S E R V I C E N O T E

3852A Data Acquisition/Control Unit**Serial Numbers:** 2927A00000 / 2927A12048**Incorrectly Labeled Line Voltage Switches May Cause Switch Setting Confusion****Situation:**

**Figure 1. AC Line Voltage Switch Positions****Solution/Action:**

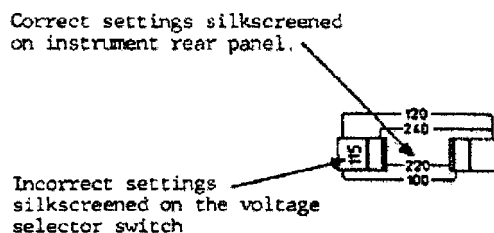
Some units may have incorrectly labeled line voltage selection switches installed. The correct settings appear silkscreened on the instrument rear panel. The incorrect settings are silkscreened on the voltage selection switches themselves.

No action is required. However, to avoid confusion, the incorrectly silkscreened line voltages may be easily scratched off using a flat-head screwdriver.
